SUBJECT: NuScale Power, LLC Response to NRC Request for Additional Information (RAI No. 9833 and 9834) on the NuScale Topical Report, "Building Design and Analysis Methodology for Safety-Related Structures," TR-0920-71621, Revision 0

Response to Request for Additional Information Docket: 99902078

RAI No.: 9834

Figure 5-3 Member modeled with two rows of solid-shell elements through the thickness

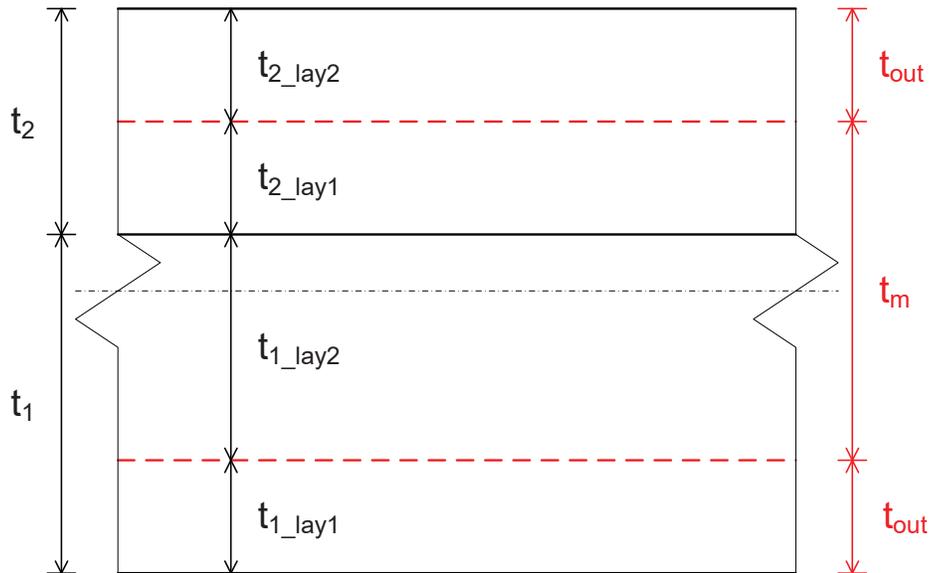
- 1) In Section 5.5.2.1, "Method 1 for Implementing Effective Stiffness Using SOLSH190 Elements," it is confusing which numbers are used to specify the outer layers: are they 1 and 2 or 1 and 3? Figure 5-2 shows they should be 1 and 3 and so does the equation on page 31. However, it seems the equations on pages 32 and 33 indicate that they are 1 and 2.
- 2) In Section 5.5.2, "Implementation of Effective Stiffness Values for Solid-Shell Elements," the text refers to AISC 4-16 which is not in the reference list.

- 1) Clarify the layer numbers used to refer the outer layers.
- 2) Correct the reference standard.
- 3) Clarify and, if necessary, correct the equations.
- 4) Verify that referenced equations (5-12), (5-13), and (5-17) are correct; if not, correct.
- 5) Clarify whether equation (5-29) for the orthotropic material is correct as written. If not, correct.
- 6) Clarify whether the referred equation in AISC 690-18 is correct. If not, correct.

TR-0920-71621 Figure 5-2, not revised as part of this response, shows the three-layered solid-shell element outer material layers as 1 and 3. This numbering applies to walls and slabs modeled with a single row of elements through the thickness. TR-0920-71621 is revised to state that the thickness of the outer layers (layers 1 and 3 in Figure 5-2) is calculated as: $t_{1,3} = (t - t_m)/2$.

TR-0920-71621 refers to walls and slabs modeled with two rows of solid-shell elements. In this context, as shown on Figure 5-3, the thicknesses t_1 and t_2 refer to thicknesses of the two rows of finite elements and not material layer numbers. Each row of elements has two material layers. Material layers within the two rows of finite elements are labeled "t1-lay1", "t1-lay2", "t2-lay1" and "t2-lay2". TR-0920-71621 is revised for clarification .

Figure 8-9 Section cuts for one-way and two-way shear in basemat subject to wall overturning
~~Section cuts for out of plane shear (red) and bending (blue) in basemat subject to wall overturning~~

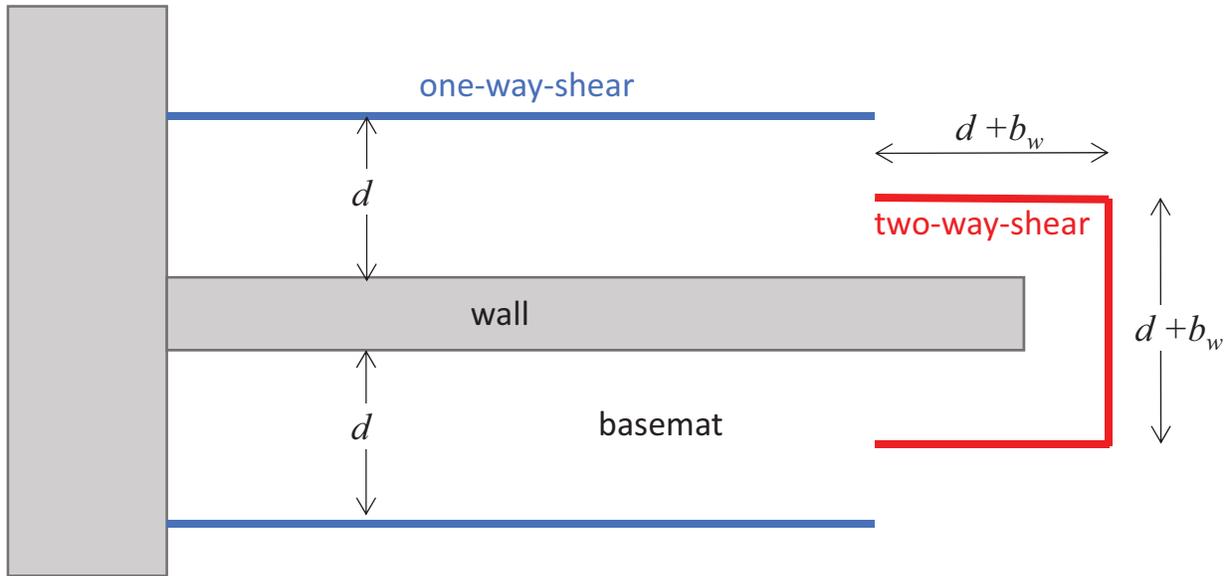
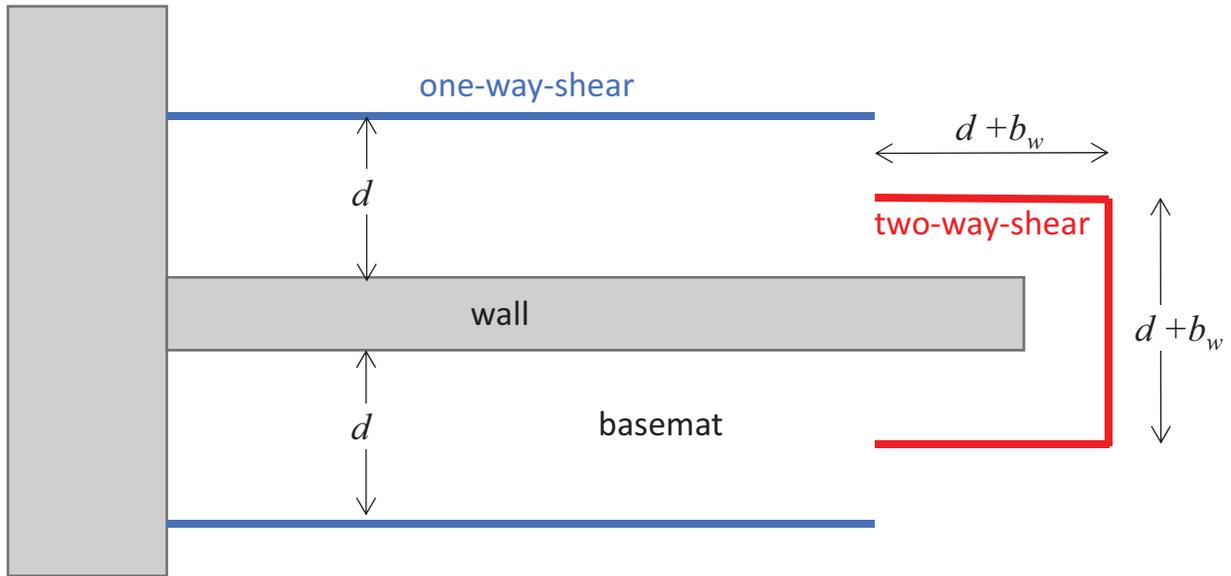
1. In Figure 8-9 of the TR, the applicant depicted the out-of-plane shear (shown in red) section cut "d" distance (from extreme compression fiber to centroid of longitudinal tension reinforcement) away from the wall. It is not clear to the staff why the applicant chose a distance of "d" for the out-of-plane shear (shown in red) section cut.

Response Request (a): ACI 318 Section 11.1.3.1 and ACI 349 Section 11.1, which directly references ACI 318 Section 11.1 and its subsections, states that "For nonprestressed members, sections located less than a distance d from face of support shall be permitted to be designed for V_u computed at a distance d ". TR-0920-71621 Figure 8-9 considers the wall to act as support to the basemat for out-of-plane shear, thus, the design demand is calculated at a section cut that is d distance from the face of the wall.

Response Request (b): The use of the section cut for one-way shear in TR-0920-71621 Figure 8-9 is a conservative approach to evaluate the out-of-plane shear in the basemat region next to the wall ends. It is included due to its simplicity in calculating the shear demand at this section cut. However, as noted by the Staff, the basemat resists the shear coming from the end regions of the walls through two-way (punching type) shear. Thus, TR-0920-71621 Section 8.5.1 and TR-0920-71621 Figures 8-9 and 8-10 are updated to evaluate both one-way shear along the wall length and two-way shear at the wall ends as recommended by the Staff.

The basemat region outside the two-way shear region is subject to one-way shear. In this case, the out-of-plane shear demand is obtained at the section cuts shown in blue in Figure 8-9. In agreement with ACI 318 Section 11.1.3.1, the section cut is located at one basemat effective depth, d , from the face of the wall.

Figure 8-10 Section cuts for out-of-plane bending in basemat subject to wall overturning
~~Section cut for two way shear in basemat subject to wall overturning~~

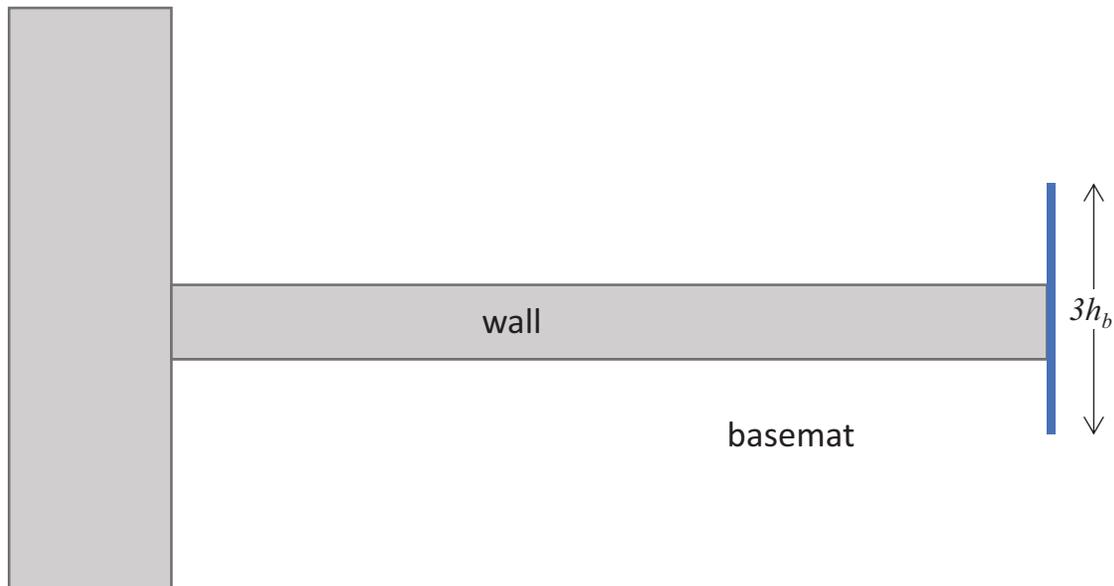
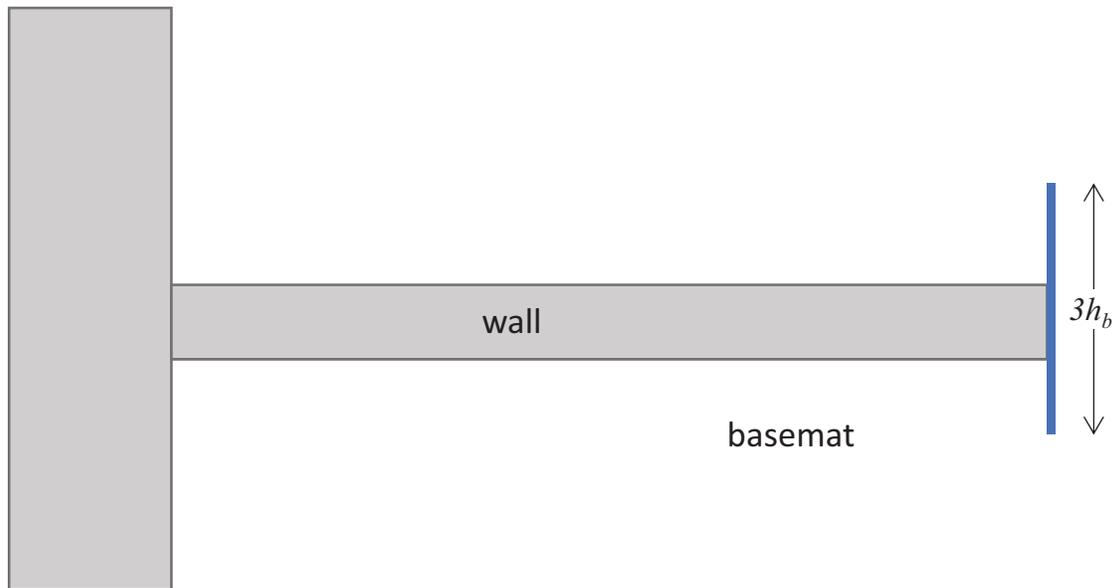
2. In Figure 8-10, "Section cut for two-way shear in basemat subject to wall overturning," of the TR, the applicant depicted the square section cut, in red, with a distance of "d+b_w," at each side at the end of continuous wall. In Section 8.5.1, "Section Cuts for Out-of-Plane Forces," the applicant also stated, *"if the out-of-plane shear demand calculated at these section cuts exceeds the basemat capacity corresponding to one-way or beam shear, then the failure mode would change to two-way or punching shear. In this situation, the shear capacity associated with this failure mode is instead considered and the associated demands are calculated at the section cut shown in red in Figure 8-10."*

However, it is not clear to the staff the source for the change of the failure mode of section

The section cut location for out-of-plane bending due to wall overturning is shown in blue in ~~Figure 8-9~~ Figure 8-10. Based on recommendations in Reference 10.1.29, the section cut length is limited to three times the basemat thickness.
